Planning Commission Staff Report

May 25, 2016
Item 6.a.

SUBJECT: PUD-118

PURPOSE: Work Session to review and receive comments on applications for: (1) certificate of appropriateness to demolish all existing structures; and (2) Planned Unit Development (PUD) Rezoning and Development Plan to construct an approximately 2,032-square-foot, three-story mixed-use building with office/retail space on the first-floor and three apartments on the second- and third-floors and three, three-story, detached single-family homes.

Figure 4: Site Plan

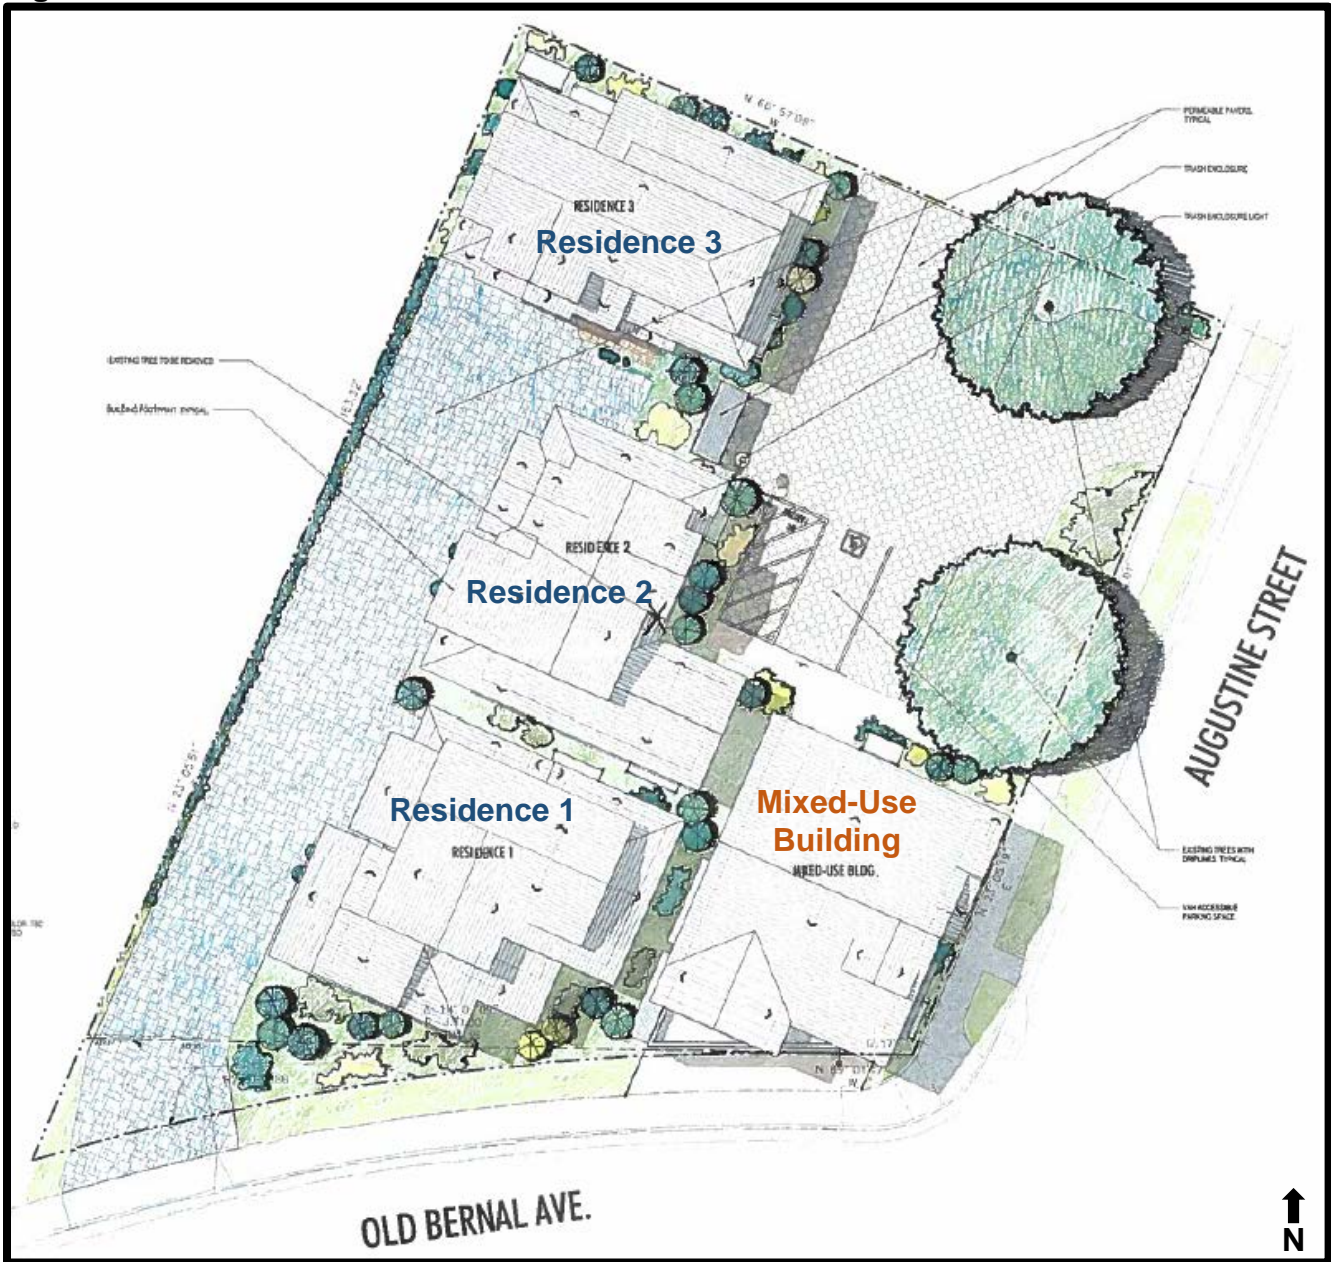
As proposed, the project is not consistent with the General Plan and Downtown Specific Plan land use designations. The General Plan and Downtown Specific Plan encourage multi-family housing above ground-floor office space(s). The majority of the project comprises detached, for sale single-family homes, which would make the subject project inconsistent with its respective Office land use designations. In staff's opinion, the project has a small amount of office/retail space and would not be consistent with the intent of the Office designation. A building consistent with the Office designation would include ground floor office space with multi-family units above.

B. Should the project be revised to conform to the existing Downtown Specific Plan Office designation (office on ground-floors and multi-family on the upper-levels)?

The PMC parking requirements for a mixed-use building would be nine on-site spaces (i.e., two spaces for each apartment unit and three spaces for the office/retail space based on a 1 space/300 sq. ft. parking ratio). There are six on-site parking spaces proposed for the mixed-use building and the applicant is proposing to have the apartment and office/retail tenants share the six parking spaces. Although the applicant is proposing shared parking, three additional parking spaces are still required by Code. In-lieu parking fees may be requested for Downtown projects that do not meet the parking requirements of the PMC. The applicant could be required to pay for three in-lieu parking spaces (the difference of the nine required for the mixed-use building) pursuant to PMC Section 18.88.120. Although shared parking is not a means permitted in the PMC to reduce parking requirements, and could add additional demand to Downtown parking supplies, staff notes that the small rental apartment units are likely to have reduced parking demand compared to typical residential units and are located in close proximity to transit facilities (the ACE train station, located on Pleasanton Avenue, and Wheels bus stop along Old Bernal Avenue). In addition, shared parking has other benefits that may be considered – including the potential to reduce housing costs, enhance urban design, and make more effective use of scarce Downtown land.

D. Does the Planning Commission support parking facilities that are shared by the office/retail space and upper apartment units?

Figure 5: Mixed-Use Building

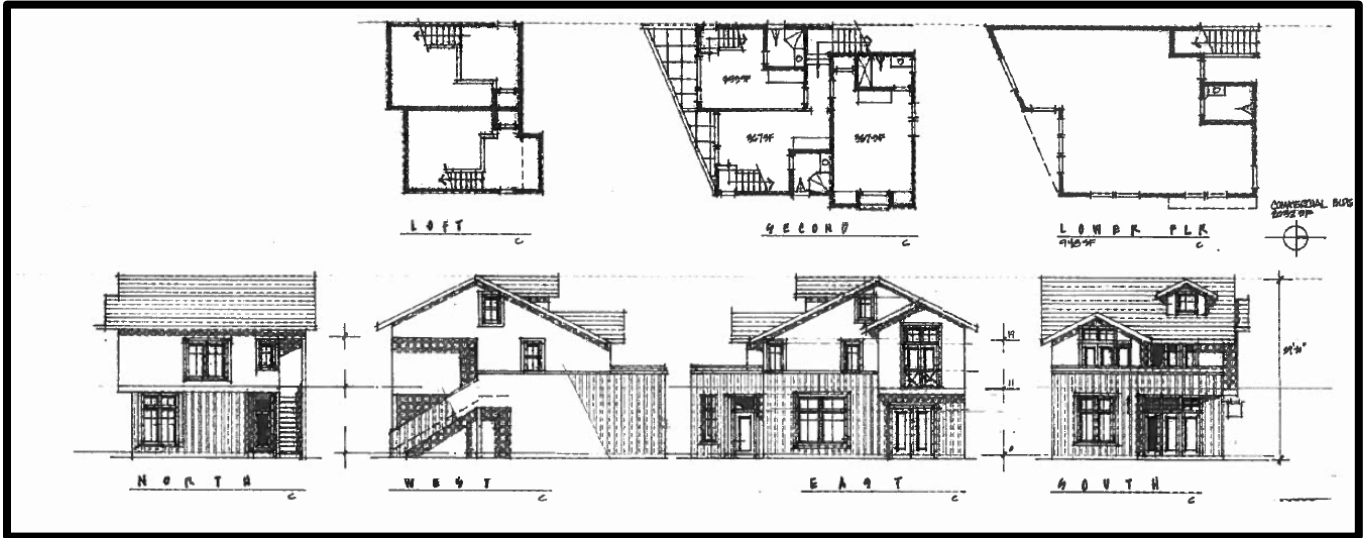
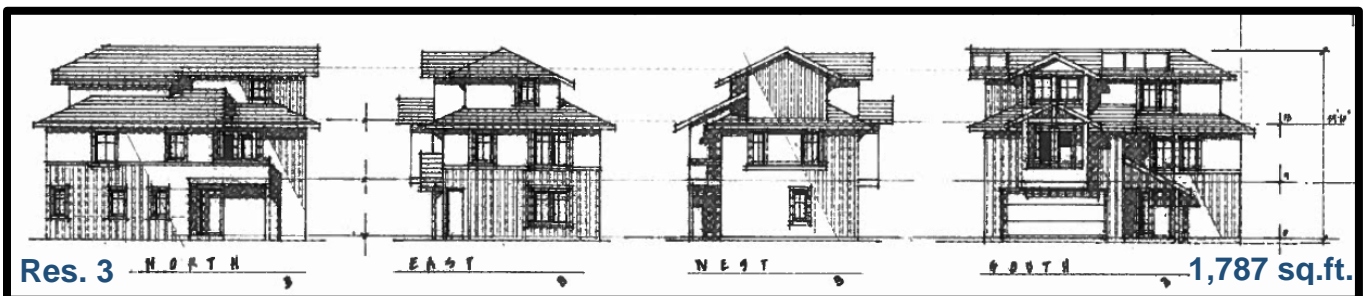
Staff initially had concerns that the proposed architecture was not compatible with the design character of the Downtown. The initial application proposed vertical and horizontal board-and-batten and shiplap siding, metal siding, stucco, and a combination of standing seam metal and composition roof materials. The applicant revised the plans to improve the materials being used by eliminating the horizontal shiplap siding and reducing the amount of metal siding. Staff notes that the changes are not reflected on the color and material sheet in Exhibit B.

The mixed-use building would provide an at-grade entrance to the office/retail space and provide display windows that would provide a pedestrian friendly storefront element. The storefront windows and the use of a variety of façade materials, including stucco, wood, and metal would add to the architectural variety of the Downtown.

The project incorporates acceptable building materials for the Downtown and would be consistent with the Specific Plan policy to use high quality building materials appropriate to the architectural style of the building. The plans incorporate articulation in the wall planes, balconies, traditional design features (porches, knee braces, gable roof), and a combination of light colored materials. The proposed building colors meet the Downtown Design Guidelines, which state that colors should be appropriate to the architectural style of the building.

F. Are the proposed building designs, area, massing, number of stories, heights, and colors and materials acceptable and compatible with the Downtown and surrounding area?

Figure 6: Single-Family Homes

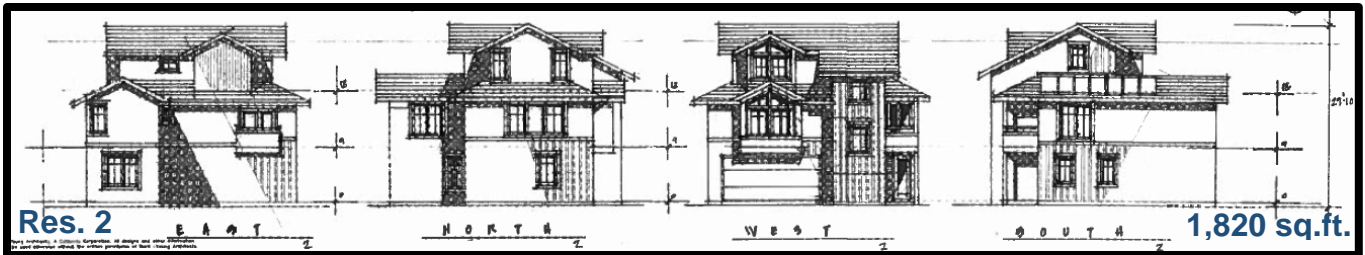
The height of the buildings would not exceed 30 feet in height, which is considered acceptable in most residential zones within the City. Staff notes that a PMC amendment for limiting height and stories of structures in the Downtown has not yet been initiated and the intent of this policy

is to limit development to two stories. However, staff believes the proposal would be consistent with a reasonable interpretation of the Downtown Specific Plan Land Use policy in the absence of an amendment to the PMC relating to building height. Furthermore, if the project is revised to be consistent with the Office district (as suggested by staff), Policy 15 would not apply.

The applicant is proposing traditional architecture with modern elements. The materials, colors, and details of construction are based upon a “modern farmhouse” style that is characterized by wood and metal siding, front porches, prominent porch supports, knee braces, and gable roof. These details are also found in Craftsman and Minimal Traditional architecture. Although the use of metal siding and standing seam metal roofs are not consistent with the Downtown Design Guidelines, staff believes the materials are high-quality and appropriately used in a way that is sensitive to the historic design quality of Downtown.
